UNITED STATES
DEPARTMENT OF THE INTERIOR
BUREAU OF LAND MANAGEMENTCarlsbad Field Office
DOD HobbsFORM APPROVED
OMB NO. 1004-0137
Expires: January 31, 2018**SUNDRY NOTICES AND REPORTS ON WELLS**
*Do not use this form for proposals to drill or to re-enter an abandoned well. Use form 3160-3 (APD) for such proposals.*5. Lease Serial No.
NMLC032096B

☐ Oil Well ☐ Gas Well ☒ Other: INJECTION8. Well Name and No.
EAST BLINEBRY DRINKARD UNIT 272. Name of Operator
APACHE CORPORATIONContact: REESA FISHER
E-Mail: Reesa.Fisher@apachecorp.com

Proposed conformance procedure to workover this injection well

**Apache Corporation
East Blinebry Drinkard Unit 27
API 3002506535
May 24, 2018**

Proposed

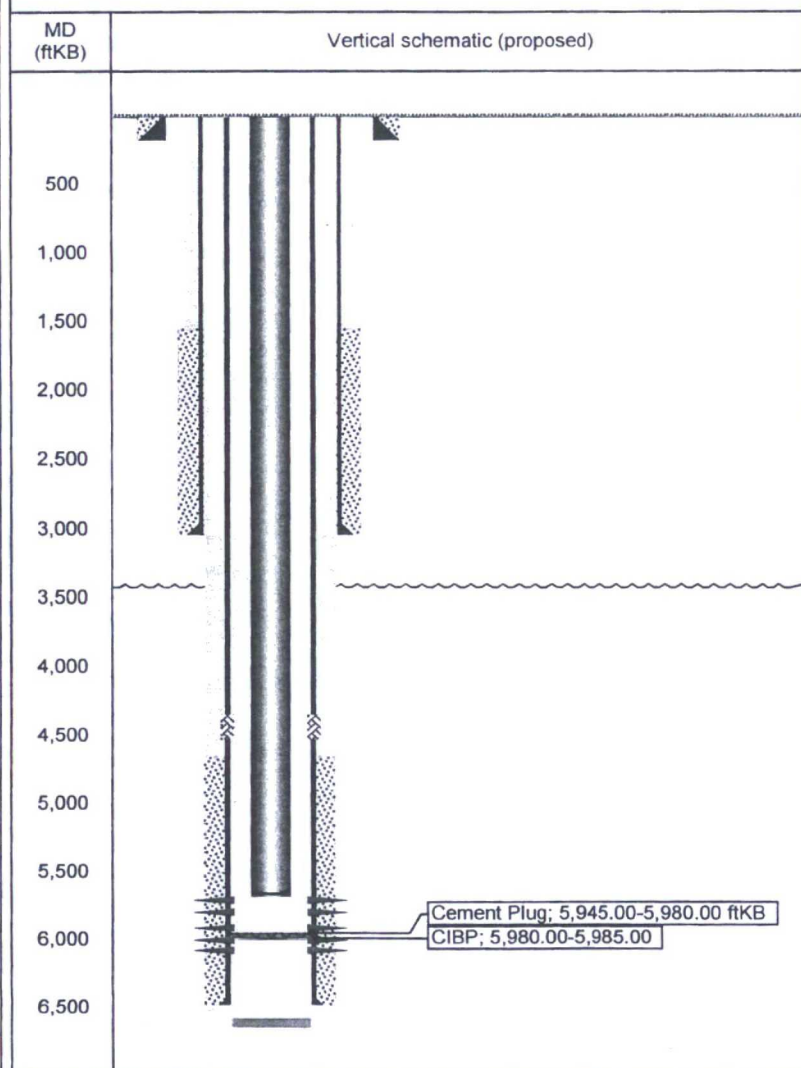
Remedial work needs to be done either on 8 5/8" or 5 1/2" casing in order to bring cement to surface or tie-back at least 200' into previous casing.
